# Access Compliance Report

## Public Rights-of-Way

### (Curb Ramps)

Intersection ID: 10541	Main Street: CANTON_PL	Cross Street: POLK_ST	Location: E
ADA ID: 099EB249DDAB	Ramp Type: Perp	Initial Pass/Fail: Fail	Overall Compliance: No
			Severity Score: 21.25

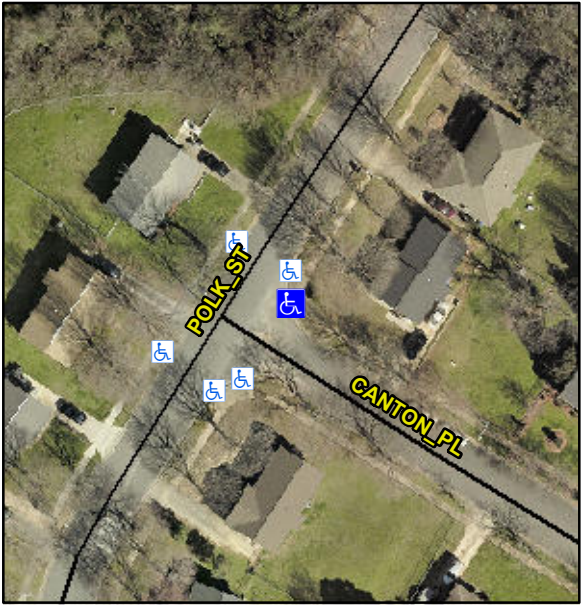
Codes/Mitigation Info/Possible Solution			Field Measurements/Component Compliance		
	Possible Solutions:		<b>Compliance</b>	<b>Description</b>	<b>Data</b>
	<b>Remove &amp; Replace Entire Ramp.</b>		<b>No</b>	Ramp Length (in)	80.5
			<b>No</b>	Ramp Width (in)	47.0
			<b>N/A</b>	Flare Type LT	N/A
			<b>N/A</b>	Flare Slope LT (%)	N/A
			<b>N/A</b>	Flare Traversable LT?	N/A
			<b>N/A</b>	Landing Length (in)	N/A
			<b>N/A</b>	Landing Width (in)	N/A
			<b>N/A</b>	Landing Slope (%)	N/A
			<b>N/A</b>	Landing X Slope (%)	N/A
<p>Surveyor Notes:</p> <p><b>N/A</b></p> <p>PROW/ADA:</p> <p><b>Not Found, R304.5.1, R304.2.2</b></p>			<b>N/A</b>	Flare Type RT	N/A
			<b>N/A</b>	Flare Slope RT (%)	N/A
			<b>N/A</b>	Flare Traversable RT?	N/A
			<b>N/A</b>	DWS Provided?	N/A
			<b>N/A</b>	DWS Contrast?	N/A
			<b>N/A</b>	DWS Length (in)	N/A
			<b>N/A</b>	DWS Full Width?	N/A
			<b>N/A</b>	DWS Offset (in)	N/A
			<b>N/A</b>	Gutter Ponding?	N/A

<b>N/A</b>	Gutter Lip Ht (in)	0.5
			<b>No</b>	Painted X Walk1?	N/A
				X Walk 1 Direction	To SW
			<b>N/A</b>	X Walk 1 Width (in)	N/A
				X Walk 1 Slope (%)	2.1
				X Walk 1 X Slope (%)	1.3
			<b>N/A</b>	Ramp inside XWalk1?	N/A
			<b>N/A</b>	Road Slope (%)	N/A
			<b>N/A</b>	Road X Slope (%)	N/A
			<b>N/A</b>	Any Obstructions?	N/A
				Obstruction Type	
Total Cost: \$ 1850.00			<b>N/A</b>	Storm Grate/Utility Hazard?	N/A
				Storm Grate/Utility Type	
			<b>N/A</b>		N/A
			<b>Yes</b>	Surface Condition? (G/P)	Good
